Attachment B: Te Pūtahi Ladies Mile Planning Provisions - feedback received email

**FEEDBACK OF THE 495 LADIES MILE LIMITED PARTNERSHIP
 ON THE DRAFT LADIES MILE TE PUTAHI PLANNING PROVISIONS**

**FEEDBACK OF THE MILSTEAD TRUST
 ON THE DRAFT LADIES MILE TE PUTAHI PLANNING PROVISIONS**

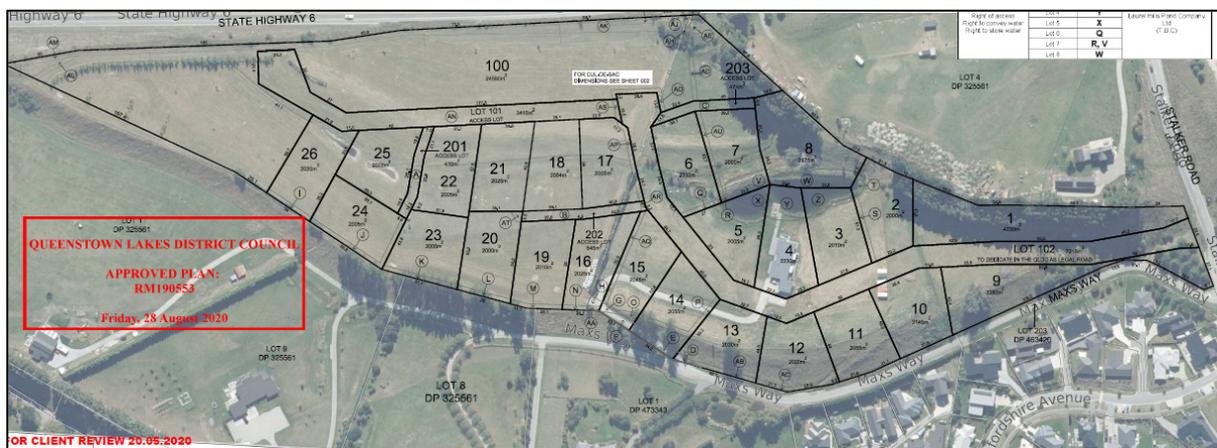
This annotation is concerning as it terminates at the base of a steep embankment, as shown in the image below.

While it might be possible to achieve required gradients with extensive cut and fill, it is submitted that this link is shown incorrectly and attempting to create a link in this location is not feasible. Alternative locations would better provide for a link. It is requested that the link be removed.

Figure 3: Earlier versions of the masterplan – Public Open Days Masterplan Options A and B

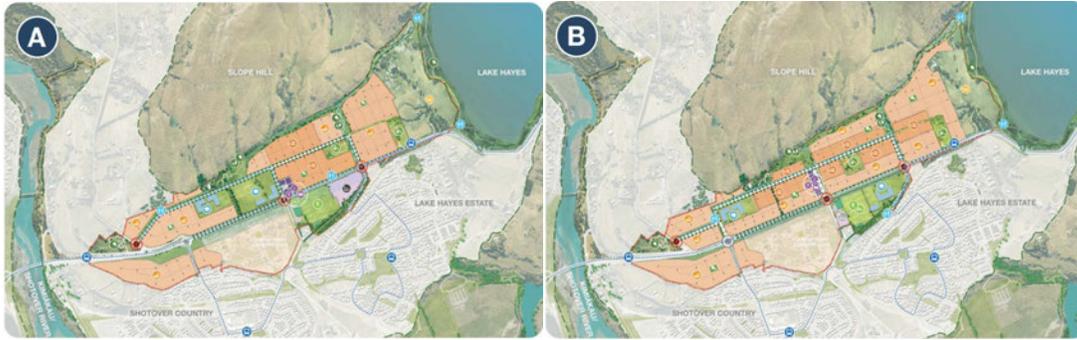
Previous consultation versions of the masterplan showed the high school further to the east (Option A) or across the road at 516 Frankton Ladies Mile Highway (Option B). The Syndicate considers 516 Frankton Ladies Mile Highway to be the most appropriate and practical site as the high school can be collocated with the bus interchange and playing fields. In terms of the specifics of Option B in relation to the Syndicate's land, this is not supported due to the location of a park over part of its land and consequential impact on residential development feasibility. The Syndicate therefore provided feedback in support of Option A during the earlier consultation period and this masterplan is still supported by the Syndicate.

Given the plans outlined above in relation to the Syndicate's development intentions for its site (that have been conveyed to the Council in previous feedback), the Syndicate is disappointed to see the high school located in this location. The Syndicate will not be able to deliver its intended medium-high density residential development if this land is taken for school purposes. The Syndicate seeks that the high school be moved from its land.
